**STATE OF MINNESOTA
MINNESOTA POLLUTION CONTROL AGENCY**

**IN THE MATTER OF THE DECISION
ON THE NEED FOR AN ENVIRONMENTAL
IMPACT STATEMENT FOR THE PROPOSED
NORTSHORE MINING COMPANY –
FURNACE 5 REACTIVATION PROJECT
LAKE COUNTY
SILVER BAY, MINNESOTA**

**FINDINGS OF FACT
CONCLUSIONS OF LAW
AND ORDER**

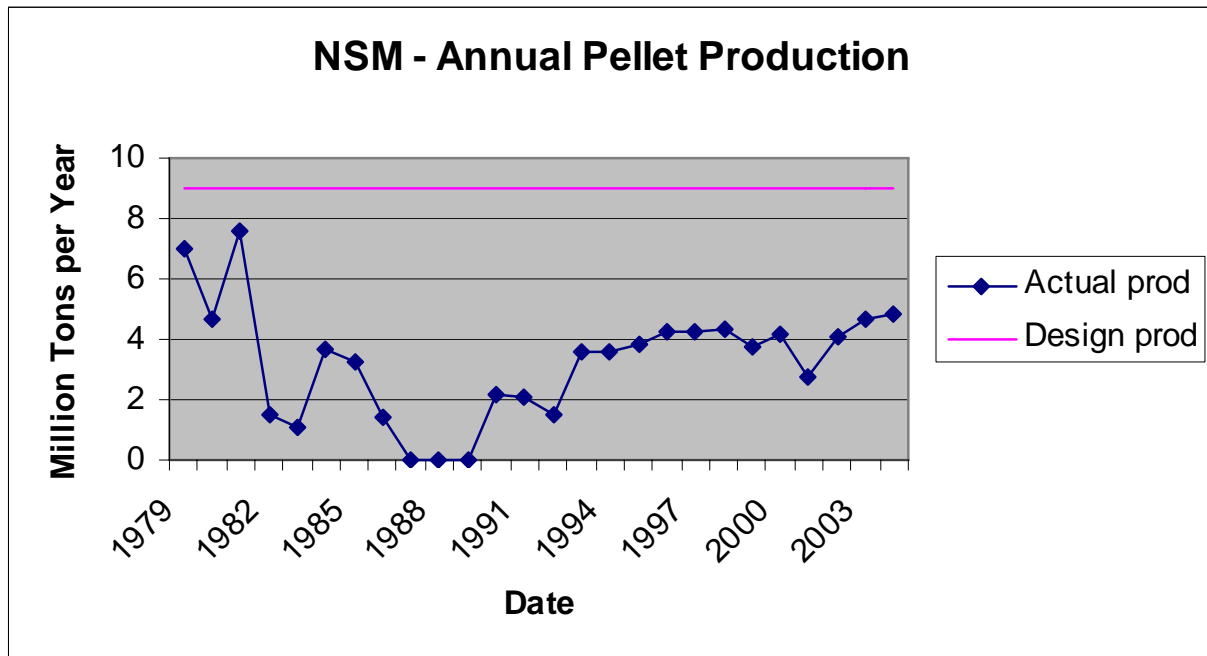
Comment 56-11: The commenter does not understand how low production of taconite pellets is related to NMC’s failure to remove adequate wastewater from the basin in the past 25 years and he states that increasing pollution to reduce pollution is not an acceptable strategy since impacts are cumulative.

Response: The consumption of water in the industrial process is directly correlated with production levels. Therefore, as production increases, the volume of water consumed in the process increases. The Mile Post 7 tailings basin was designed for full production (9.0 million tons of pellets per year). At 65 percent of full production (approximately 6 million tons per year), NMC has estimated that the taconite process consumes water at rates equal to the flow into the basin (process water plus precipitation). At production levels below 65 percent, water consumption becomes appreciably lower than the flow rates into the basin. Reduced production levels also reduce the volume of tailings available for ongoing construction of the required dams and dikes. The WWTP was designed to remove between 4.0 and 5.0 million gallons per day (MGD) of water from the basin. At the time of the design, it was believed that these discharge flow rates would maintain basin water levels, taking into account precipitation and estimated production levels. Below is a graph of the annual pellet production from 1979 through 2004, compared to the design, or full, production rate.

As can be seen in the graph, annual production each year has been below full production, and more importantly, has been below the 65 percent production value for all but two years during this time period. This time period also includes three years of no production. Therefore, there has been significant accumulation occurring within the basin that the current WWTP simply cannot remove under current conditions. Assuming production increases as proposed and remains at the proposed levels, the future

Ambient Concentration of Fibers Defined by Federal Court: Active Sites (F1 & F7) and St. Paul Sites 1978-80

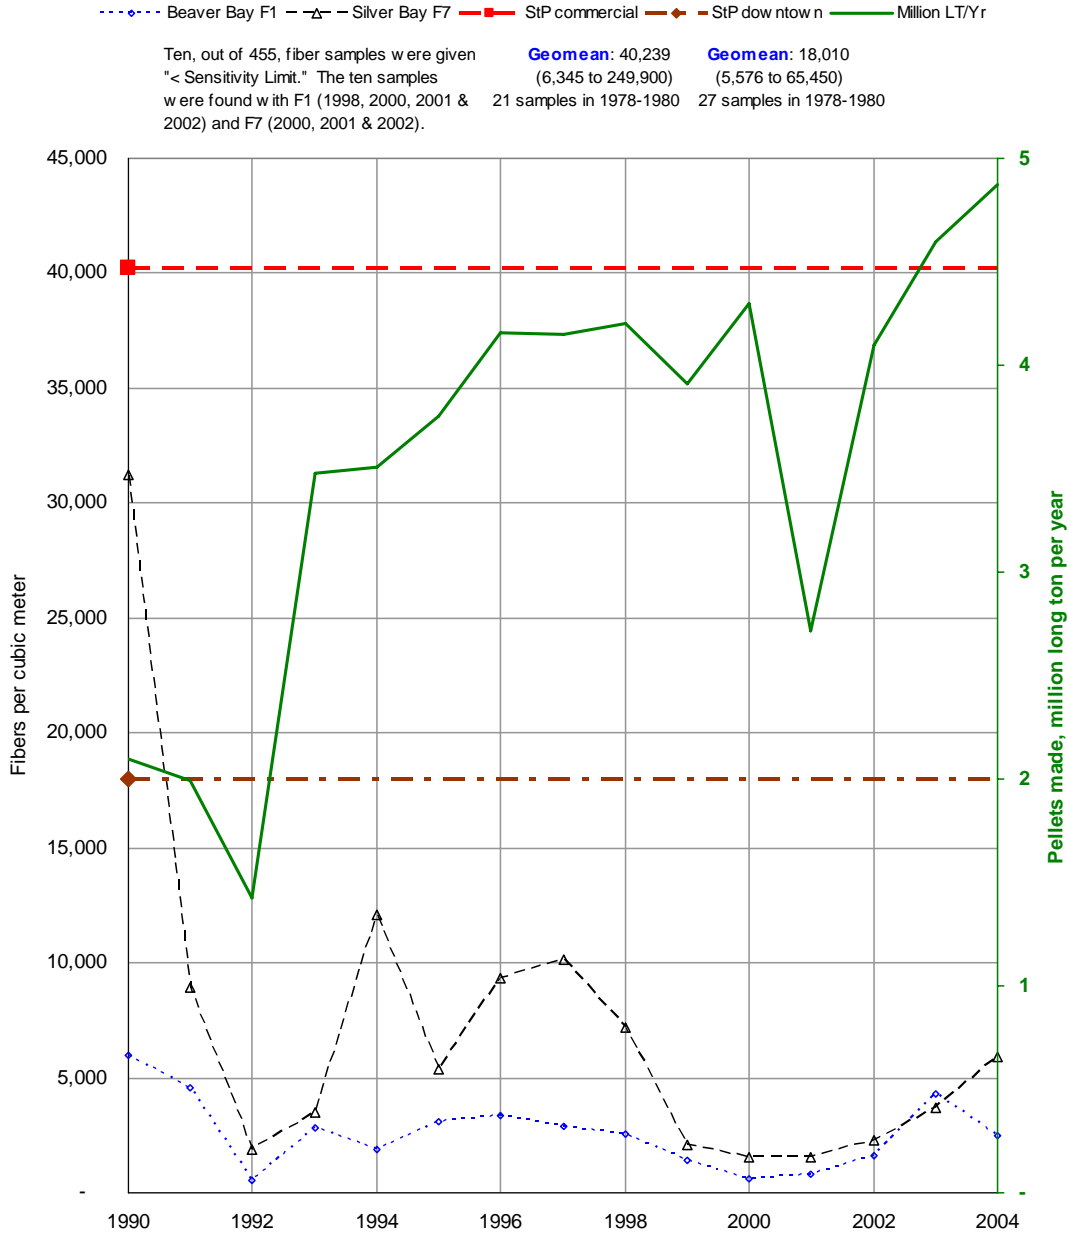
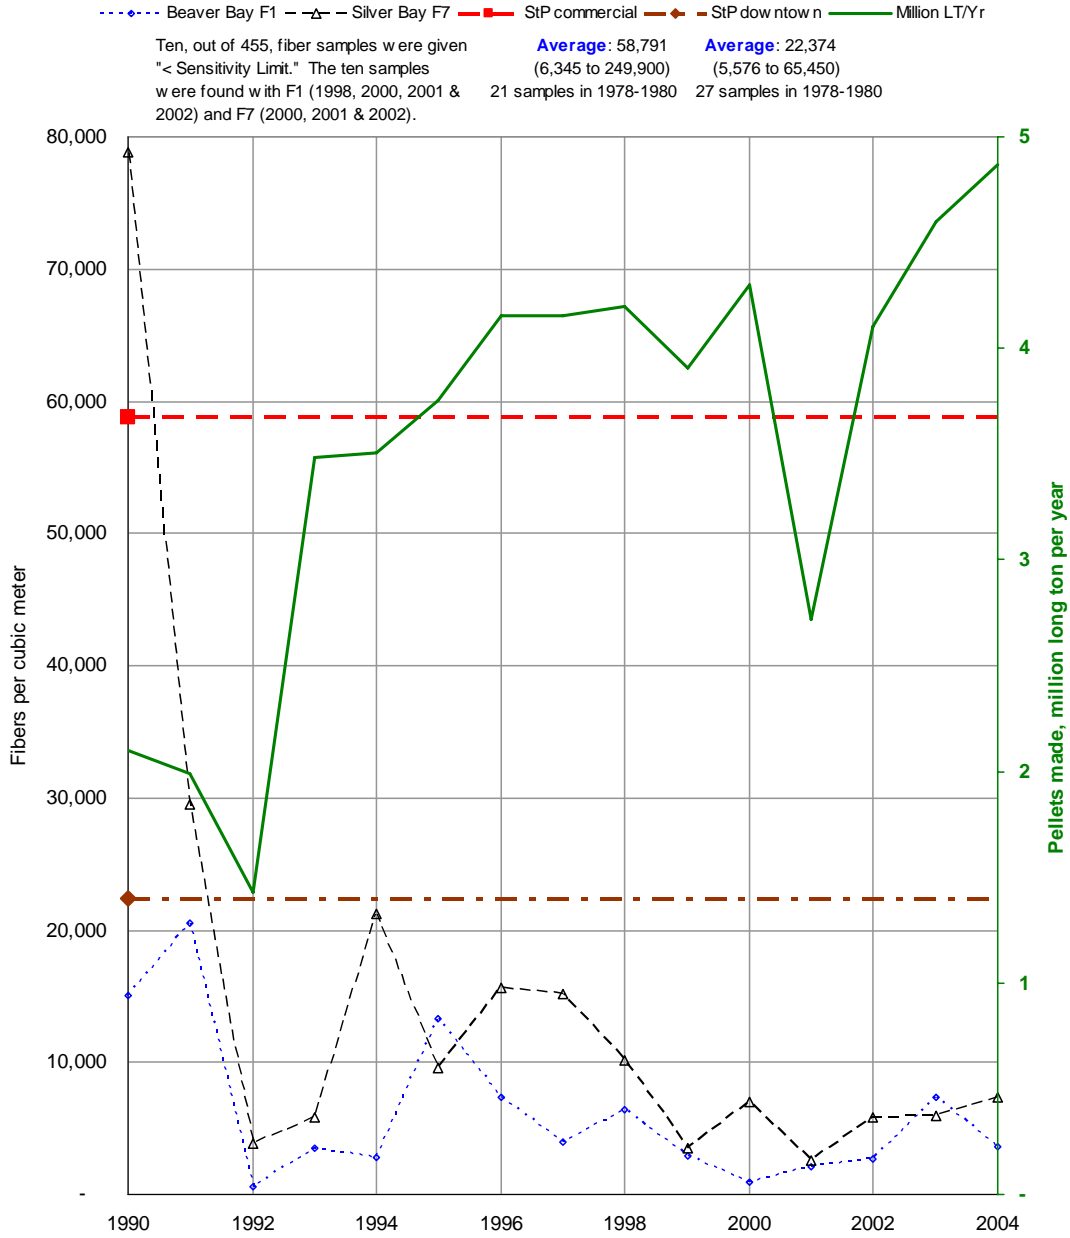
Comment 64-15: The commenter states that the original court ordered studies showed that the concentration of amphibole asbestos fibers in Silver Bay was as much as 9 times that in St. Paul in the 1970’s. A court-ordered statistical analysis by Sanford Weisberg showed that the level of mining related amphibole asbestos fibers was significantly higher at four locations in Silver Bay than those in St. Paul.

Response: The commenter is correct if only the amphibole fiber levels are compared; however, the MPCA’s fiber definition includes amphibole fibers and chrysotile fibers. Using the Sanford Weisberg results and comparing the sum of amphibole fibers and chrysotile, the current fiber levels in the Silver Bay area are below the past fiber levels (1978-1980 sampling data) in St. Paul. Below are graphs of ambient monitoring results from Silver Bay and Beaver Bay compared to two St. Paul locations (the first compares geometric means, the second compares arithmetic means). See Responses to Comments 56-26, 64-6, and 64-13.
